ADDENDUM NO. 1

RE: Capitol Cafeteria Remodeling
West Virginia State Capitol Building
Architect's Project No. 0701

FROM: ZMM, Inc. Architects And Engineers

DWG. NO. **M1-1R1**

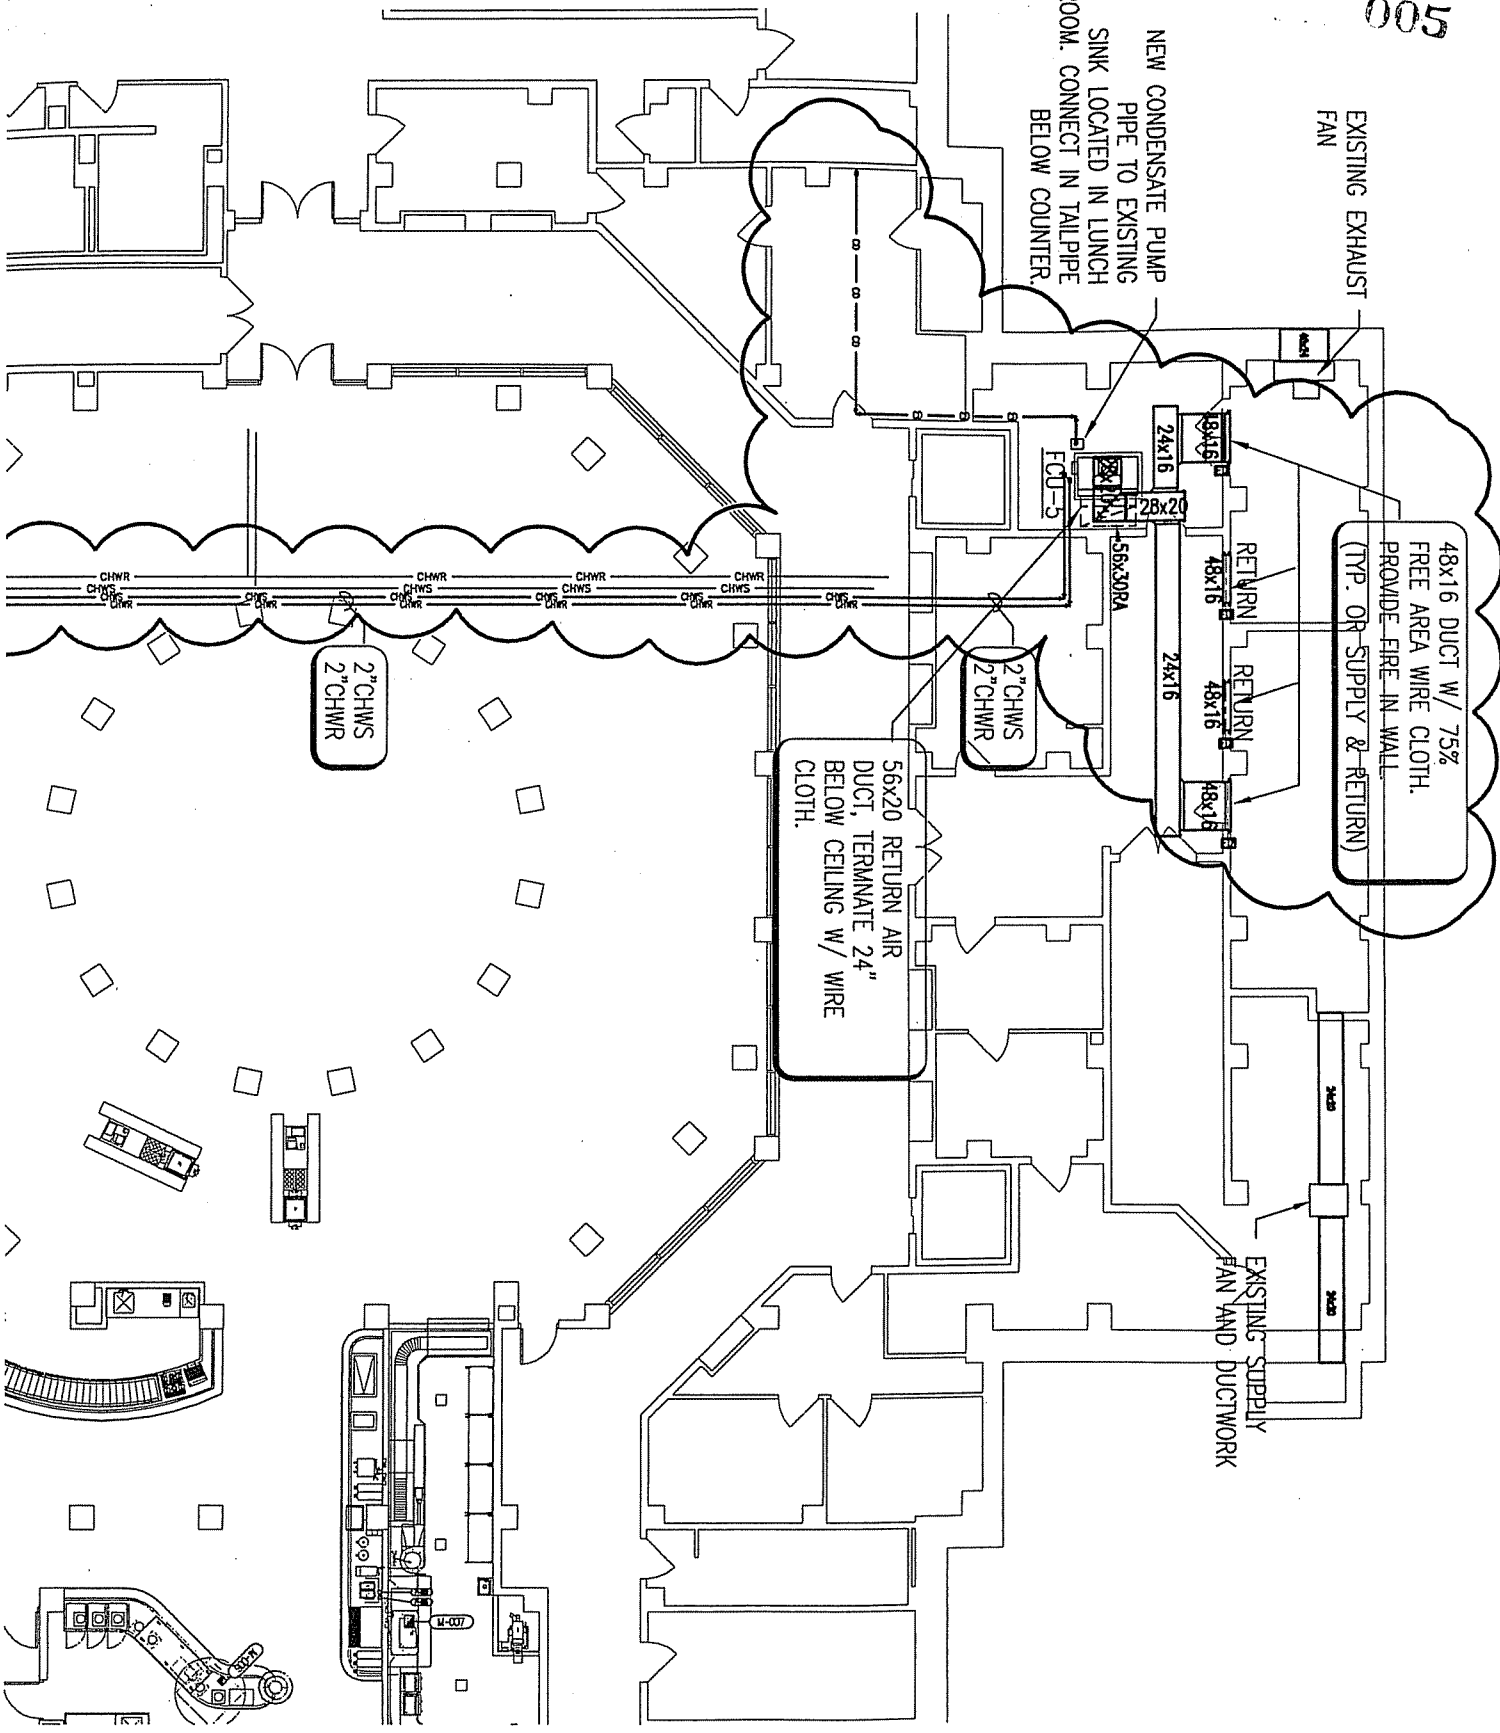
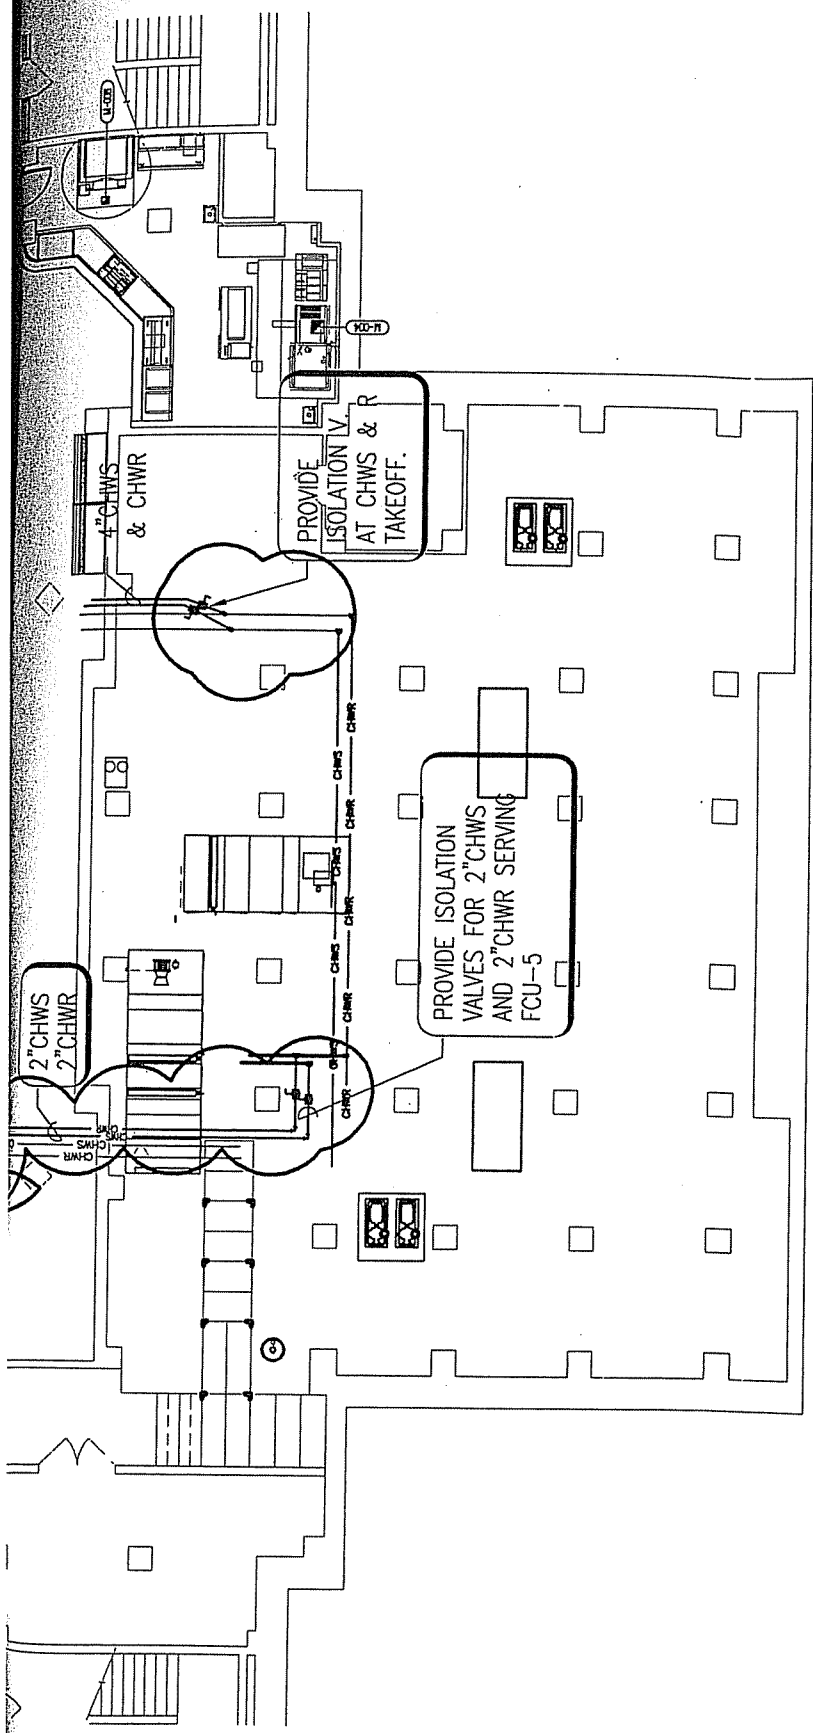
- 1. See Supplemental Drawings M1-1R1 and M3-1R1 as attached to this Addendum. Provide and install Fan Coil Unit No. 5 and related construction as indicated on these drawings.
- 2. See Supplemental Drawings E2-1R1 and E5-1R1 as attached to this Addendum.

NEW CONDENSATE PUMP
PIPE TO EXISTING
SINK LOCATED IN LUNCH
ROOM. CONNECT IN TAILPIPE
BELOW COUNTER.

48x16 DUCT W/ 75%
FREE AREA WIRE CLOTH.
PROVIDE FIRE IN WALL.
(TYP. OR SUPPLY & RETURN)

56x20 RETURN AIR
DUCT, TERMINATE 24"
BELOW CEILING W/ WIRE
CLOTH.
